ADDENDUM #1

Sylvan Union School District

New Paving & Paving Reconditioning Projects Somerset MS, Woodrow, Stockard Coffee & Sylvan Elementary Schools Modesto, California

| JOB NO. : 18M054 | EXHIBIT "A" | architecture • engineering • surveying 2257 scenic drive, Modesto, CA 95355 p. 209-523-8323 f. 209-529-7804 |

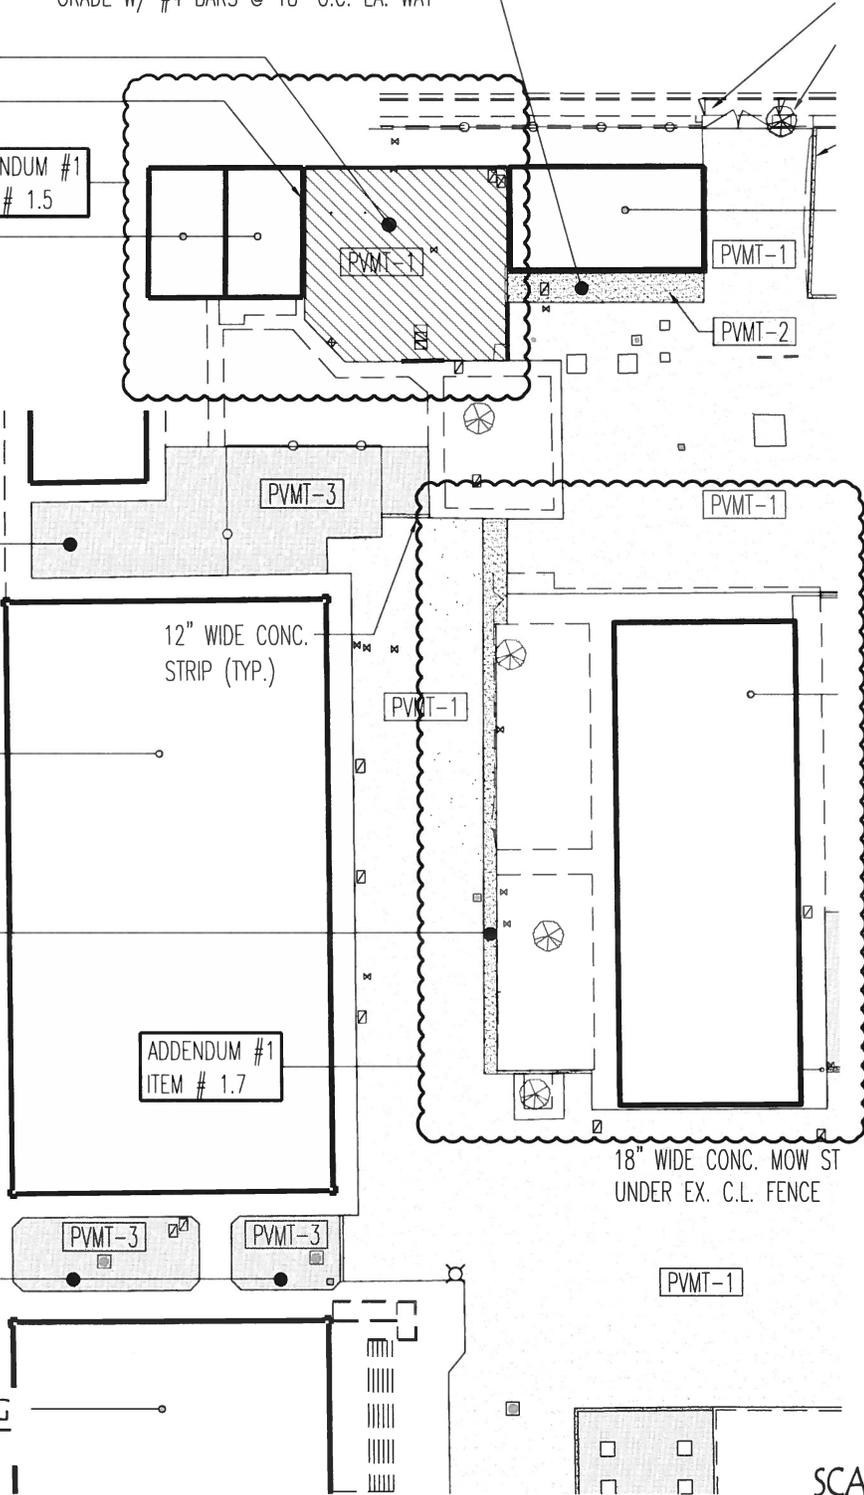
- ITEM #1.5:** **Stockard Coffee:** “Alternate #2” See the attached **Exhibit “A”**, for paving section specification. Note: Contactor shall remove the existing concrete walkways in this area and shall lower the existing utility stubs and place in concrete “Christie” box, set at grade.

- ITEM #1.7:** **Stockard Coffee:** See the attached **Exhibit “A”**, for the clarification of the concrete sidewalk, to remain, in front of the restrooms at the northeast AC playground and the location of the concrete walk, west of the Classroom Building, along the edge of the existing “turf” area.

(N) 4" THK. CONCRETE SLAB
O/V 4" AB O/V 90% COMPACTED
GRADE W/ #4 BARS @ 18" O.C. EA. WAY

(N) 4" THK. CONCRETE SLAB
O/V 4" AB O/V 90% COMPACTED
GRADE W/ #4 BARS @ 18" O.C.
EA. WAY

VALLEY GUTTER DETAIL

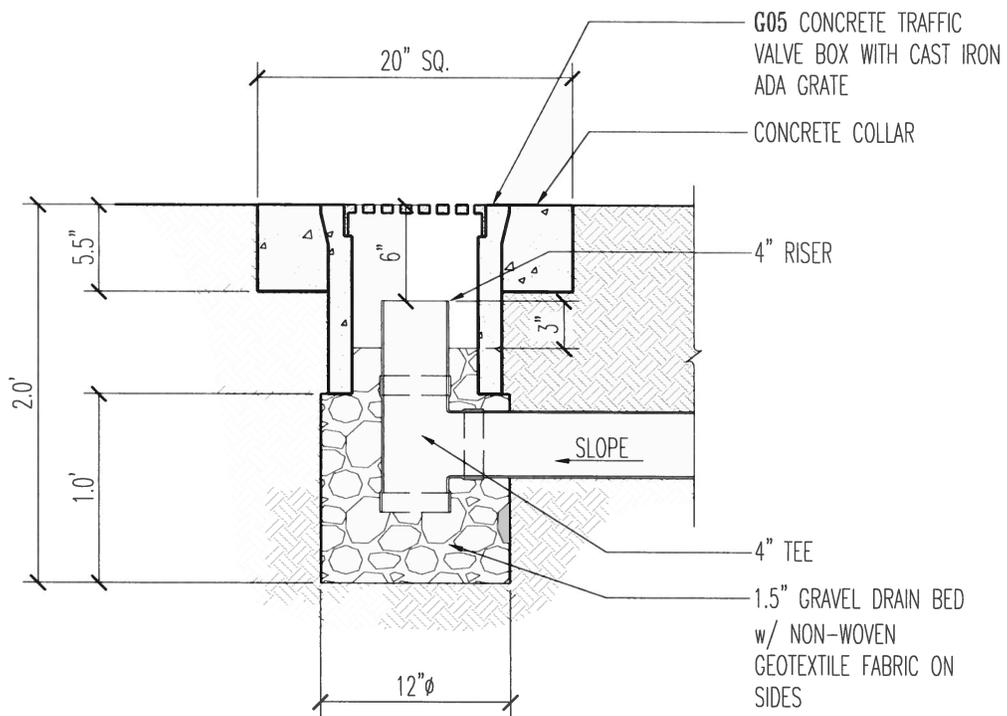
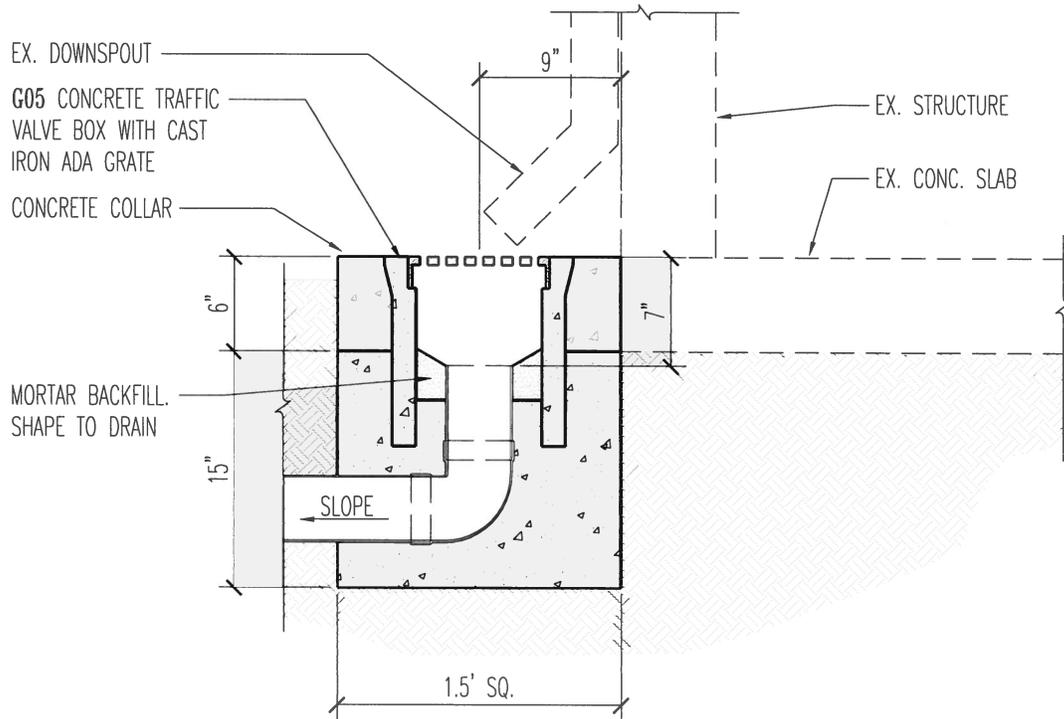
- ITEM #1.10:** **Somerset:** Valley Gutter at parking lot shall be placed over 4” compacted AB over compacted native to 90%. See **Exhibit “B”**.
- ITEM #1.11:** **Somerset:** Clarification Detail #8/Sheet C5.0 – Use 4” Concrete with #3 bars at 18” o.c., each way over compacted native.

- 1) EXPANSION JOINTS SHALL BE CONSTRUCTED EVERY 200 FEET (MAXIMUM SPACING), AT CURB RETURNS, AT CATCH BASINS AND ON BOTH SIDES OF DRIVEWAYS.
- 2) INSTALL (3) 24" LONG #5 DOWELS GREASED AND WRAPPED, ONE SIDE, THRU EACH EXPANSION JOINT.
- 3) GUTTER SHALL HAVE A FINE HAIR BROOM FINISH.

BUBBLE UP DETAIL

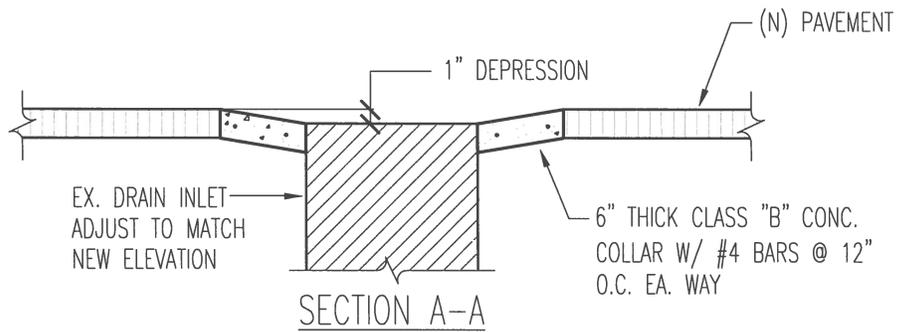
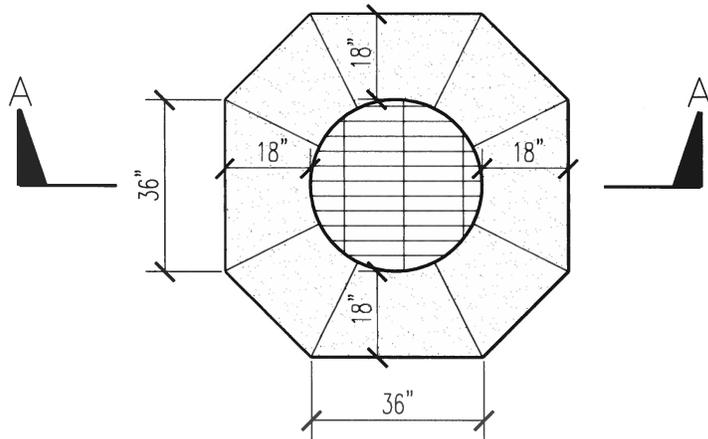
- ITEM #1.13:** **Sylvan:** Detail #14/C4.0 for (2) DI’s shown use G5 Box. See **Exhibit “C”**.
- ITEM #1.14:** **All Sites:** Where Drain Inlets are called to be adjusted to grade at new paving, contractor shall provide a concrete collar surround. See **Exhibit “D”**.

**STORM DRAINAGE
ROCKWELL ASSEMBLY WITH
TYPE I CATCH BASIN
(PROFILE VIEW)**

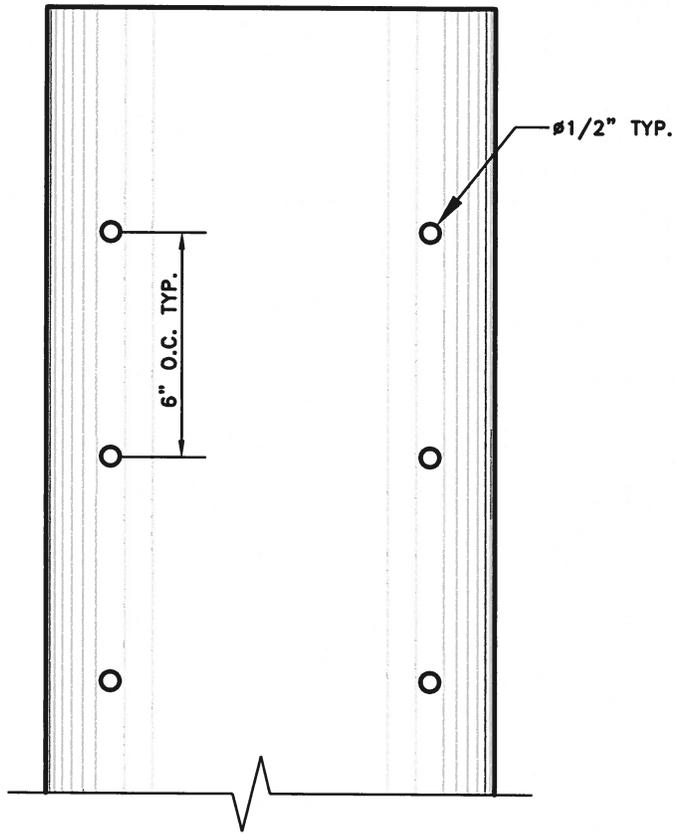
Note: Reconditioning of the drywells shall include vacuuming out the existing rock & debris, removal and replacement of the core pipe and installation of new drain rock. Per City of Modesto Standard Details #404 & #405.

1. ROCKWELLS: 8" DIA., C900 SEWER PIPE, 20' LENGTH.
2. SHALL BE INSTALLED BELL END UP.
